Service Bulletin

SUBJECT: Service Update for Inventory Vehicles Only
Turn Signal May Not Automatically Cancel

MODELS: 2013 Cadillac XTS

Subject: 13138 – Service Update Bulletin
Turn Signal May Not Automatically Cancel

3401815

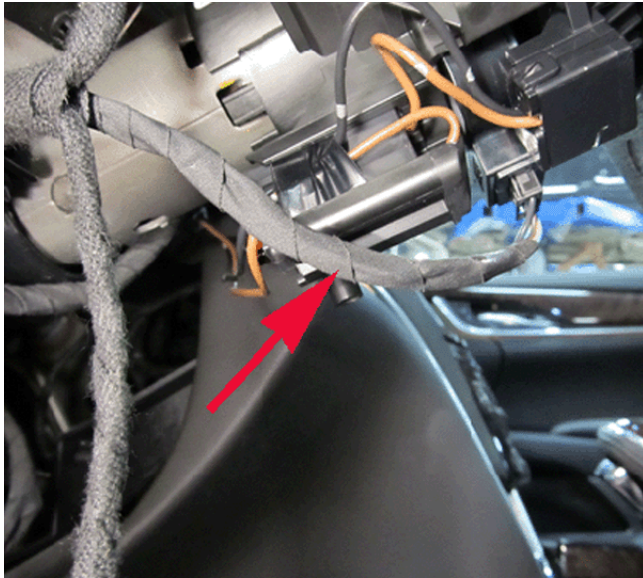
Note: The steering column wiring harness may be causing the Steering Angle Sensor (SAS) to interfere with the self-cancel mechanism of the turn signal. If the wiring harness (1) is routed on the outboard side of the column trim mounting pedestal (2), it may put strain on the 6 way SAS connector (3) causing the SAS to interfere with the turn signal cancel pawl. This interference cannot be seen. It is on the steering wheel side of the SAS. Refer to the service procedure below to reposition the steering column wiring harness and relieve the strain on the 6-way connector.

3401826

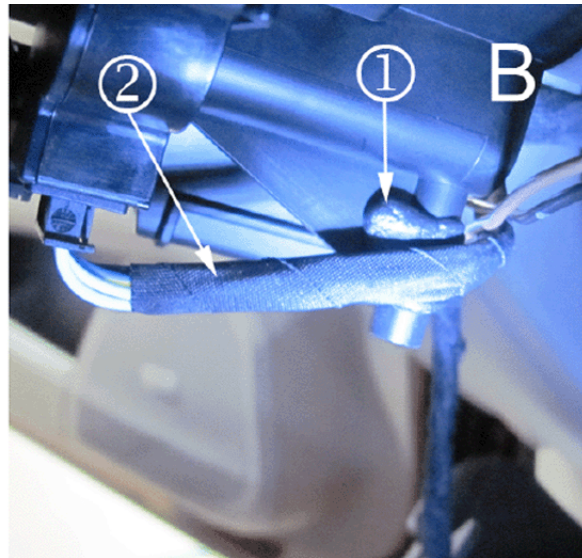
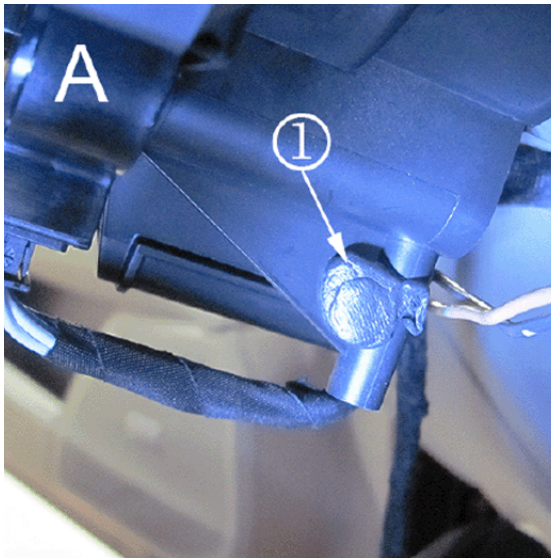
Caution: Ensure the steering column wiring harness is positioned such that it does not put tension or slack on the Steering Angle Sensor (SAS) at the connector. Any load on the SAS may cause a noise or accelerated wear within the sensor.

Note: Ensure the vehicle engine is off. It may be necessary to disconnect the 6-way SAS connector. If the connector is disconnected, the steering angle sensor will lose communication. This communication will re-establish itself when the vehicle is driven.

3. Position the steering column wiring harness (2) to the inboard side of the column electrical assembly (CEA) mounting pedestal (or right hand side from the center of the column assembly) as shown in the 'B' portion of the photograph. This step is required to route the harness in its natural form on the right hand side first.
4. Roll a 12mm (1/2 in.) piece of Kent Industries butyl tape or an equivalent butyl tape into a marble size ball.

5. Install the butyl (1) tape at the base of the column electrical assembly (CEA) mounting pedestal on the right hand/inboard side as shown in the 'A' portion of the photograph.
6. With the steering column wiring harness in the correct position, push the wire bundle into the butyl material (1) to keep the harness in position during re-installation of steering column lower trim cover. Refer to the 'B' portion of the photograph.
7. Reinstall the steering column lower trim cover. Refer to Steering Column Lower Trim Cover Replacement in SI.
8. Road test the vehicle to verify the turn signals self-cancel and to re-establish the steering angle sensor communication.
